SERVICE LETTER NO. SL-1

EFFECTIVITY: Rockwell Commander 112 S/N 3 through 79

SUBJECT: Rudder Assembly

Figure 2.

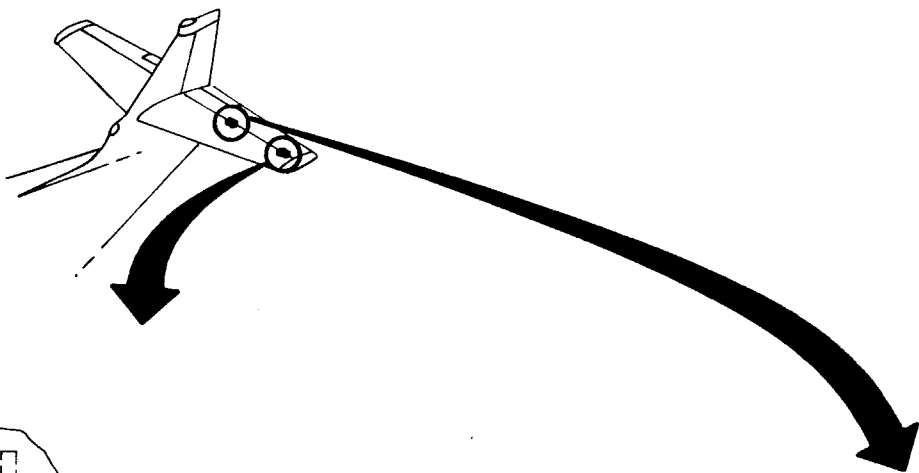
- d. Install new 44285-1 hinge fitting on elevator using existing hardware (see Figure 2.).
 - e. Attach skin to elevator structure using MS20426AD4 rivets and NAS1738B4 blind rivets.
 - f. Repaint elevator surfaces as necessary.
 - g. Reinstall tip on elevator.
18. Remove and discard existing oilite bearings from horizontal stabilizer center and outboard hinges.
 19. Install F316G bearing (4 places) on horizontal stabilizer center and outboard hinges and ream hole in bearings to 0.317/0.318-inch (see Figure 2.).
 20. Reinstall rudder assembly on airplane as outlined in the Airplane Maintenance Manual, Section VII, using existing hardware and 40111-105 bushing (see Figure 1.).

21. Reinstall left and right elevator assemblies on airplane as outlined in the Airplane Maintenance Manual, Section VII, using existing hardware, 40111-107 bushing (center hinge) and 40111-105 bushing (outboard hinge) (see Figure 2.).

Figure 1.

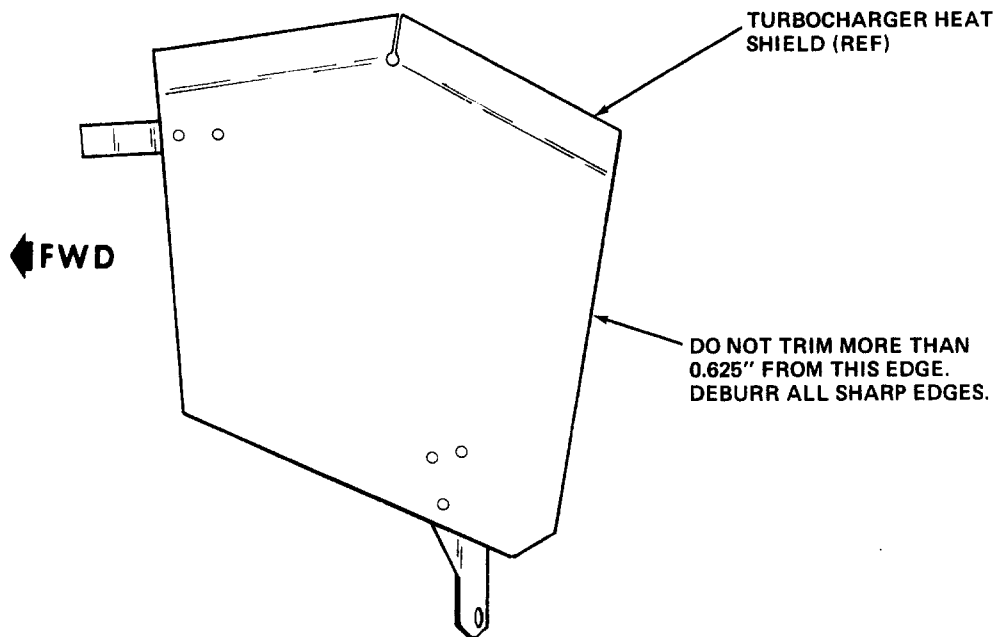
1. Remove upper cowling from engine.
2. Inspect engine mount, adjacent to turbocharger heat shield, for possible damage to engine mount (refer to Figure 1).
3. If no damage is evident and clearance between turbocharger heat shield and engine mount is 0.50-inch or more, proceed to step 7.
4. If contact between turbocharger heat shield and engine mount is evident but no major damage has occurred (see step 6), remove heat shield and trim to provide a clearance of 0.50-inch between heat shield and engine mount (refer to Figure 1).
5. Reinstall heat shield, assuring that 0.50-inch clearance is maintained.
6. If extensive damage to engine mount is evident (any penetration of the tube), contact Gulfstream American Corporation Customer Service Department for further instructions.
7. Reinstall upper cowling on engine.
8. Fill out and mail Compliance Card.

Figure 1

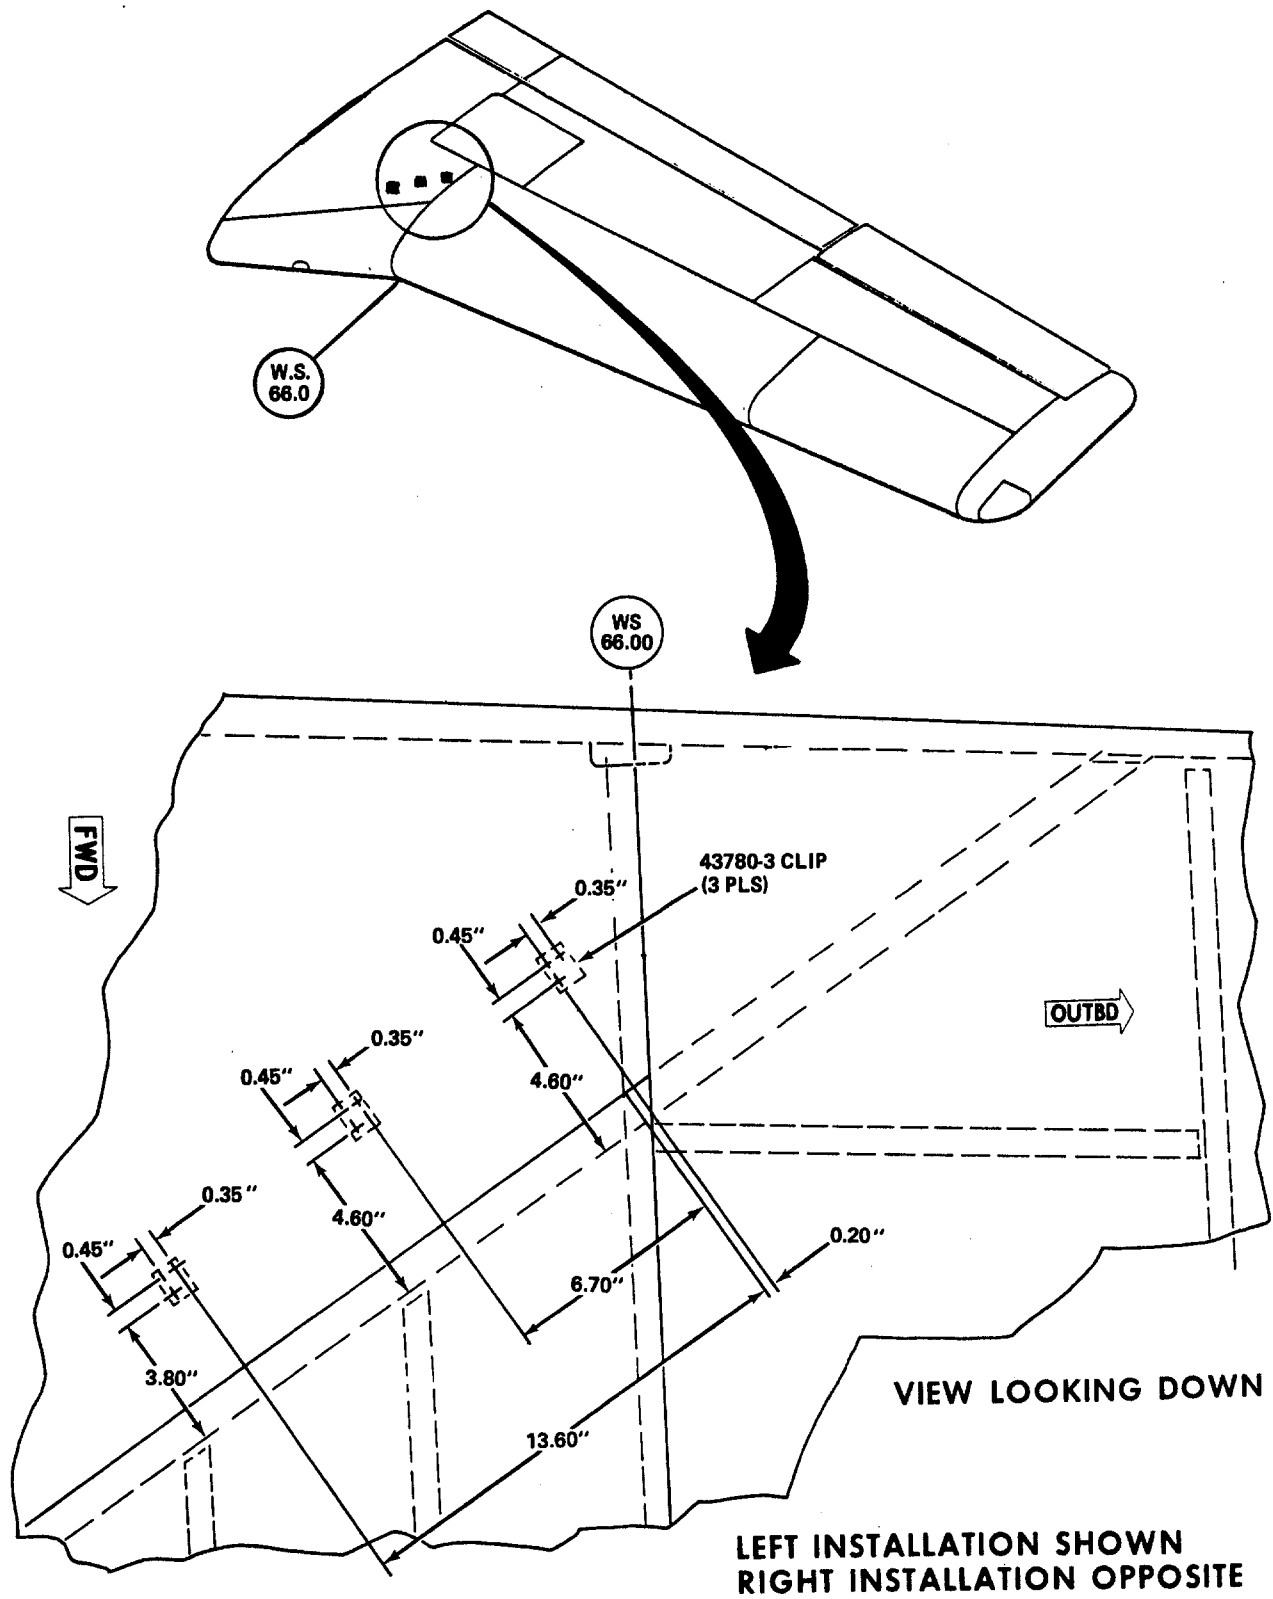
4. Locate, drill and install 43780-3 clip (3 places) on lower side of wing skin in left wheel well using MS20426AD3 rivets. Rivet heads are to be on top of wing skin (refer to Figure 1).

5. Locate, drill and install 43780-4 clip (3 places) on lower side of wing skin in right wheel well using MS20426AD3 rivets. Rivet heads are to be on top of wing skin (refer to Figure 1).

Figure 2. (Sheet 1 of 2)

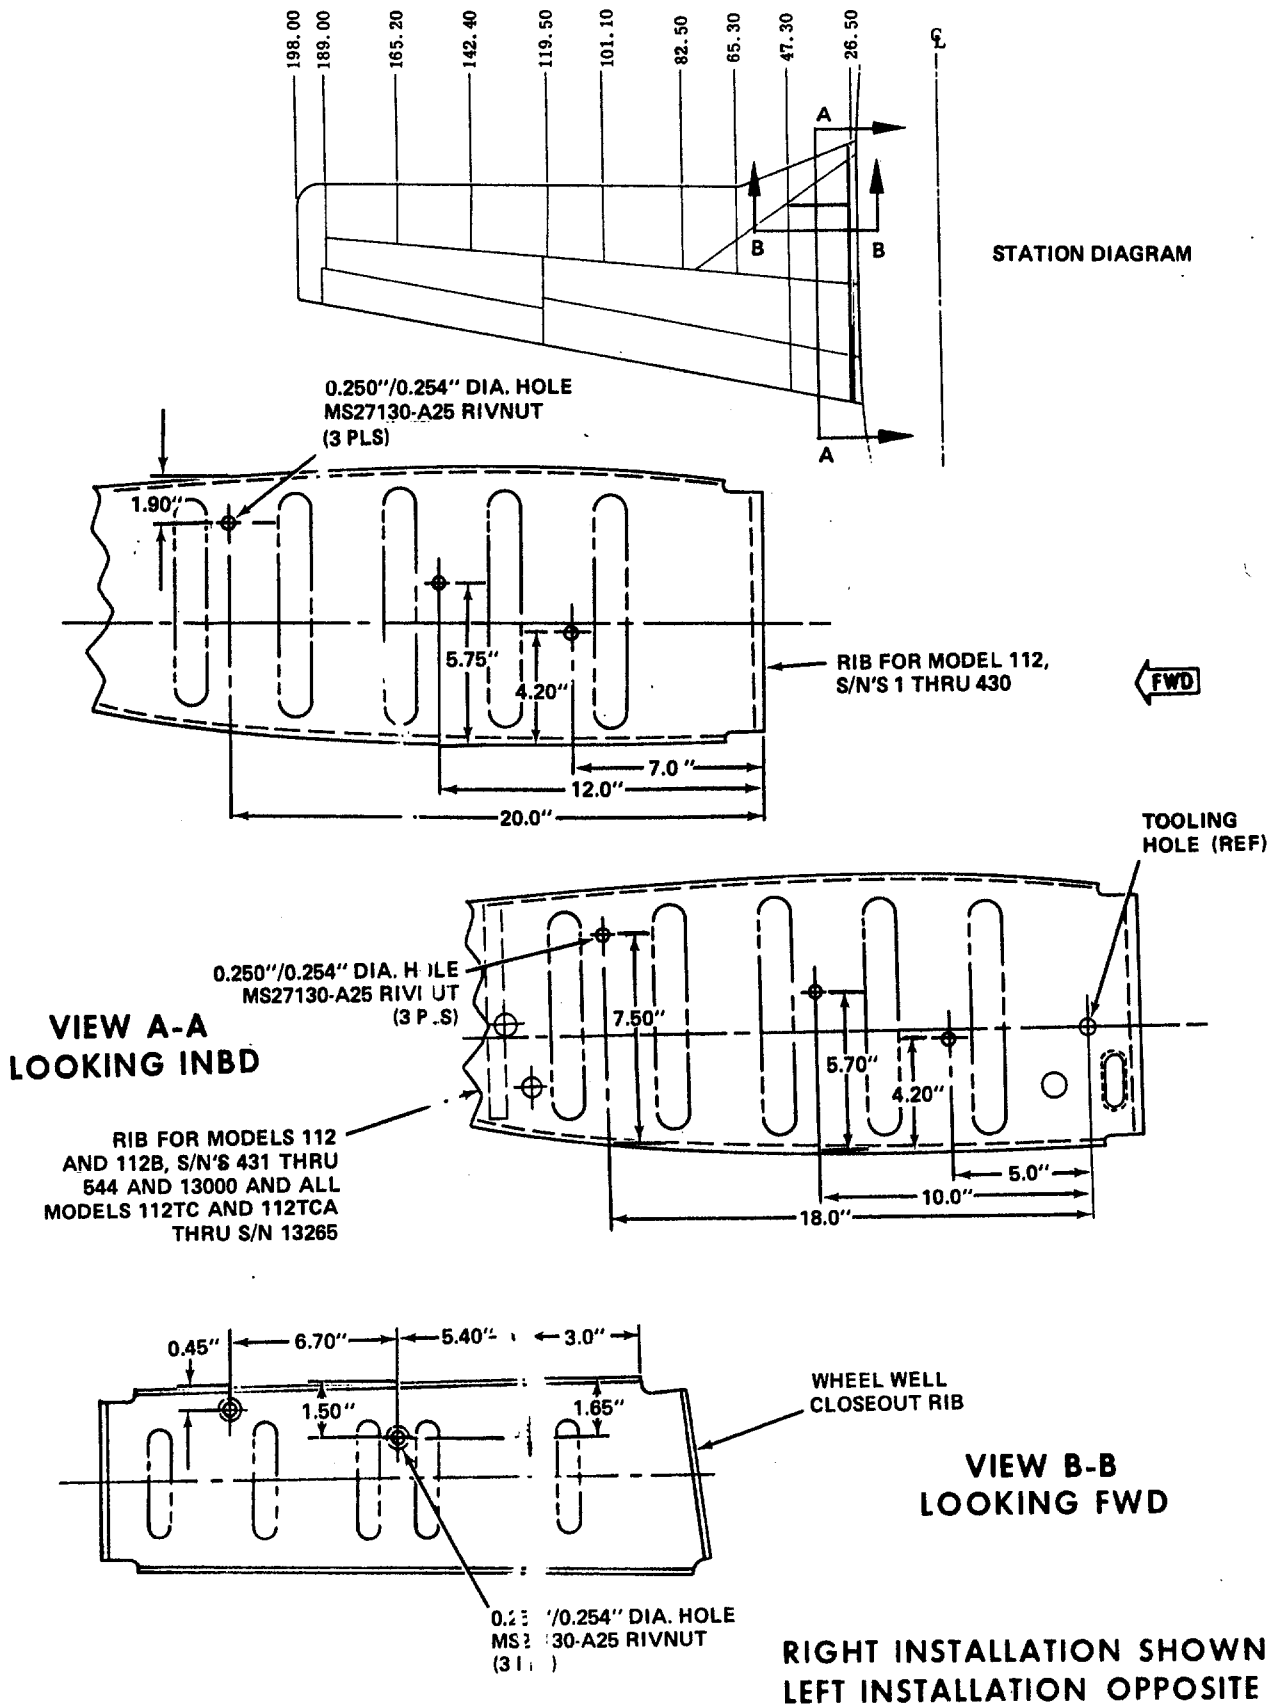
6. Locate and drill 0.252 (± 0.002) inch diameter hole (7 places) in left and right wheel well area for installation of MS27130-A25 rivnuts (refer to Figure 2).

7. Deburr all holes, prime area around holes with zinc chromate primer and install MS27130-A25 rivnuts (refer to Figure 2).
8. Locate and drill a 0.159-inch (No. 21) diameter hole, 0.63-inch deep, in right main landing gear trunnion. Tap 10-32 UNF-2B threads in hole by 0.50-inch deep (refer to Figure 3).

Figure 4.

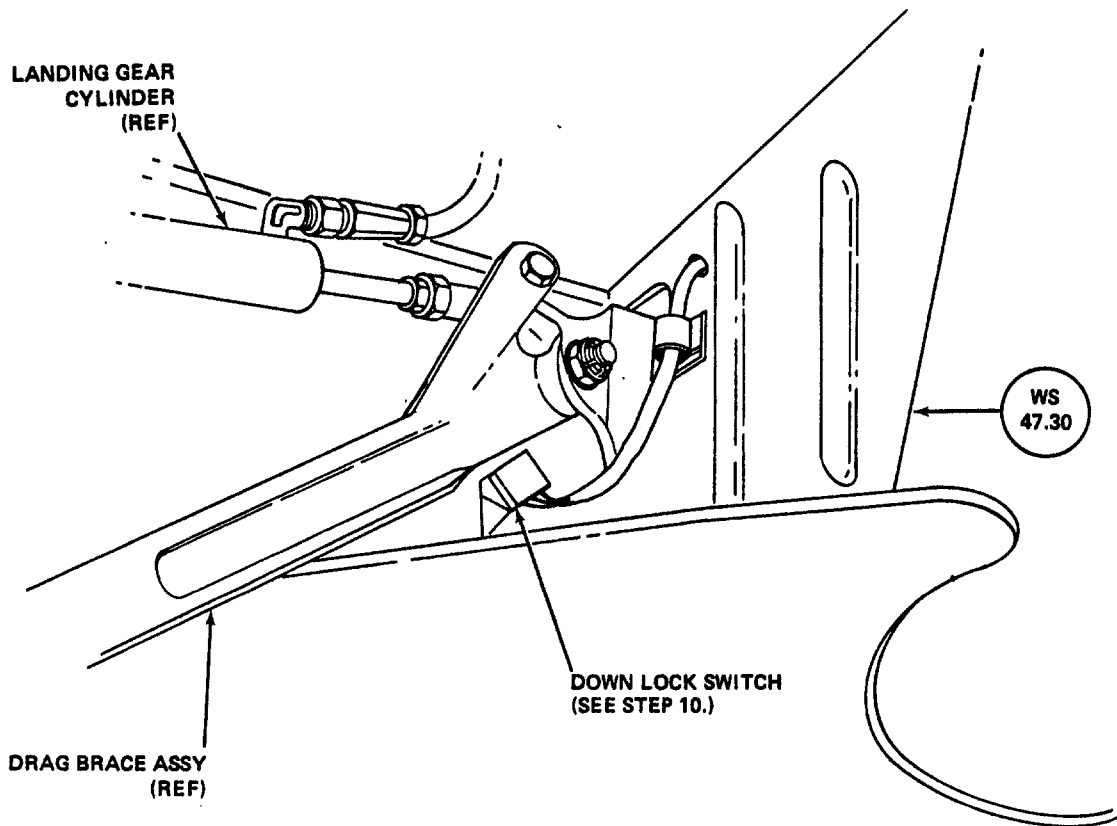
9. Check left and right main gears for location of down lock switch.
10. If down lock switch is located on upper end of drag brace assembly, proceed to step 12. (refer to Figure 4).

Figure 5. (Sheet 1 of 2)

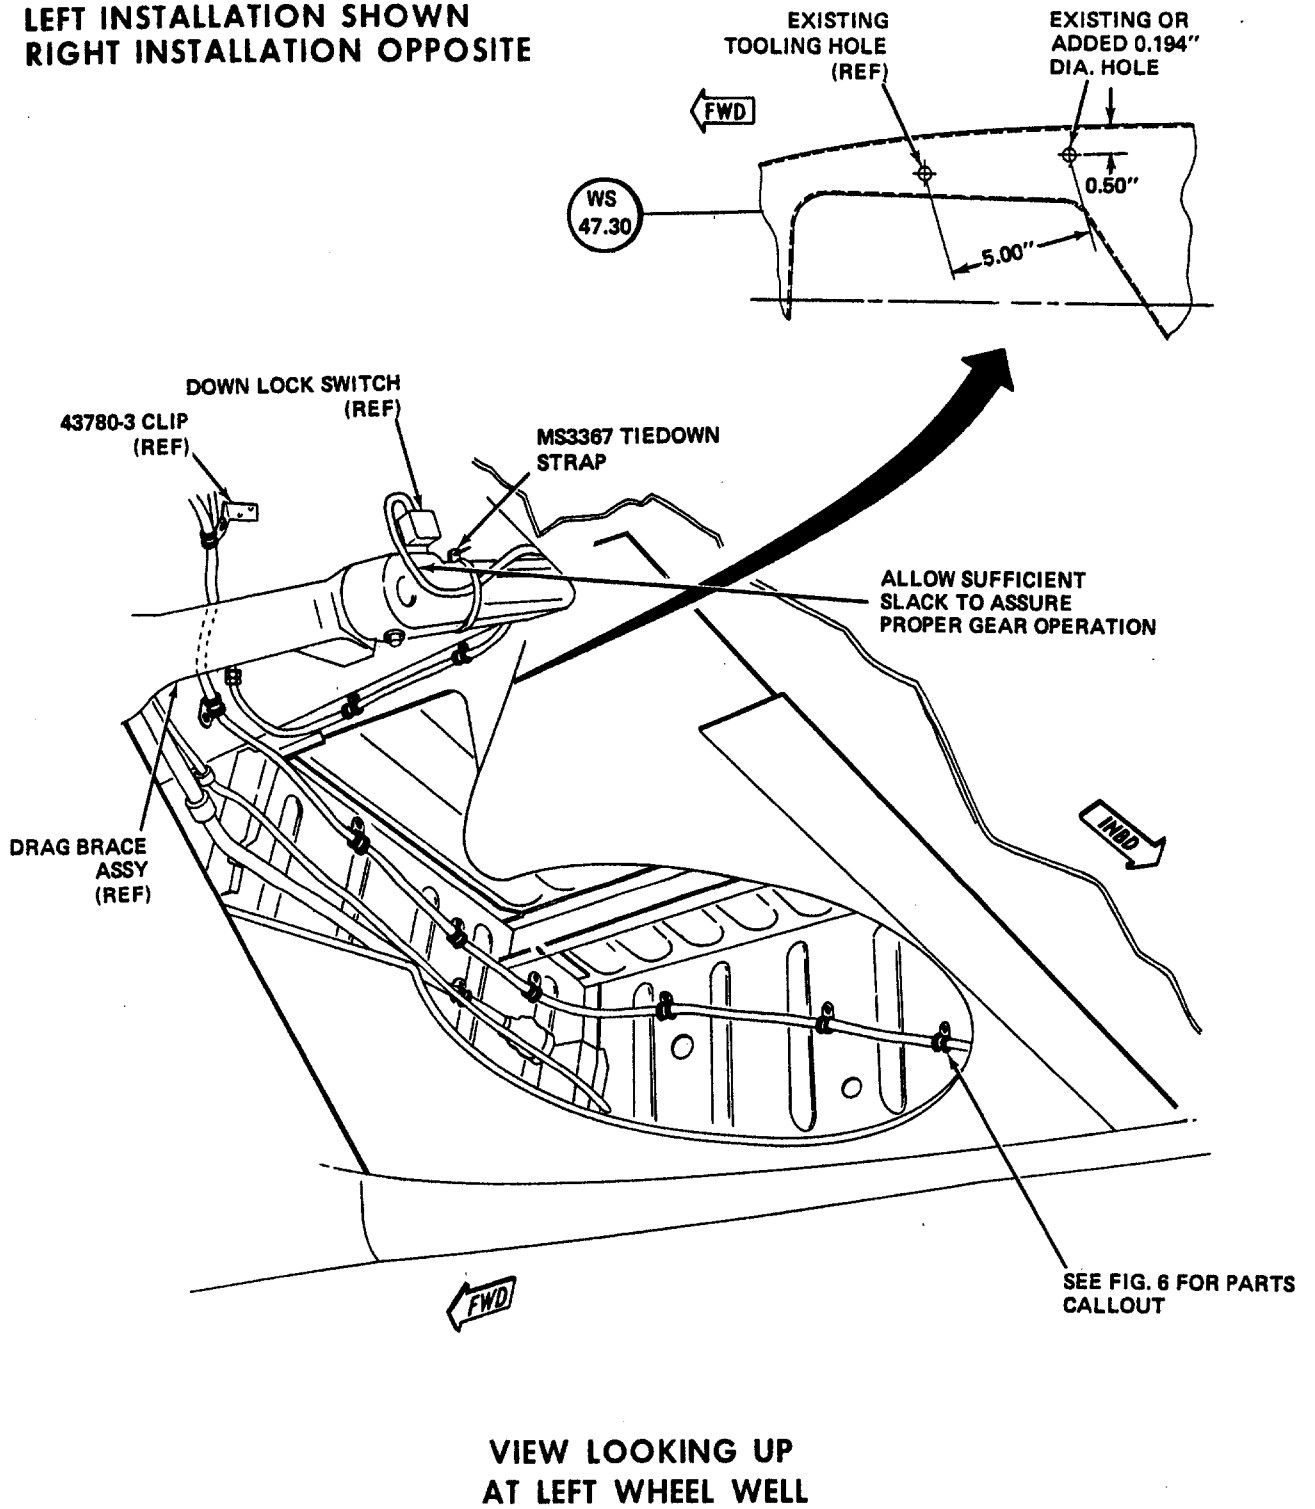
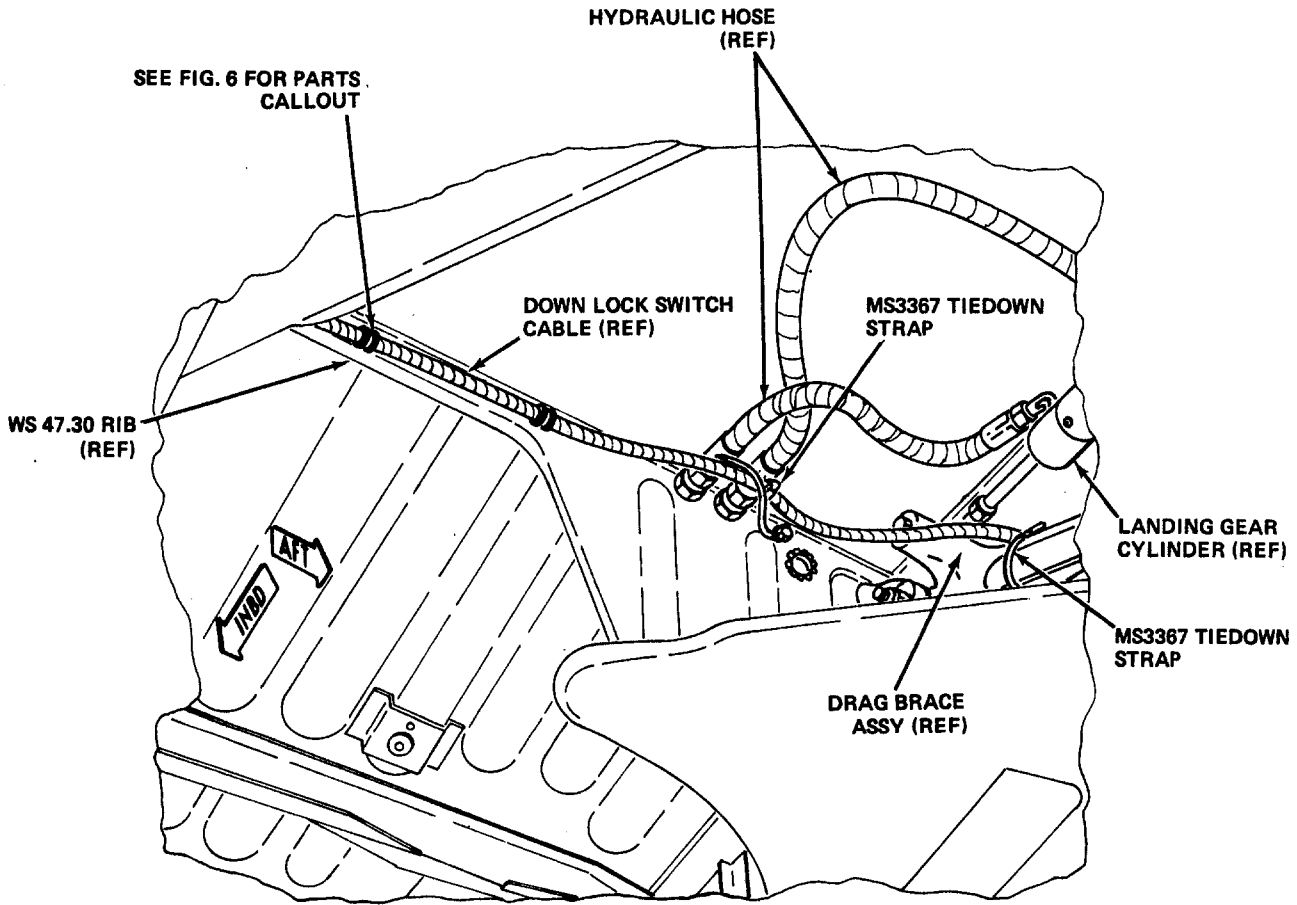
11. If down lock switch is located midway down on drag brace assembly, proceed as follows (refer to Figure 5):
 - a. Locate and drill a 0.194-inch diameter hole in wing station 47.30 rib (if necessary).
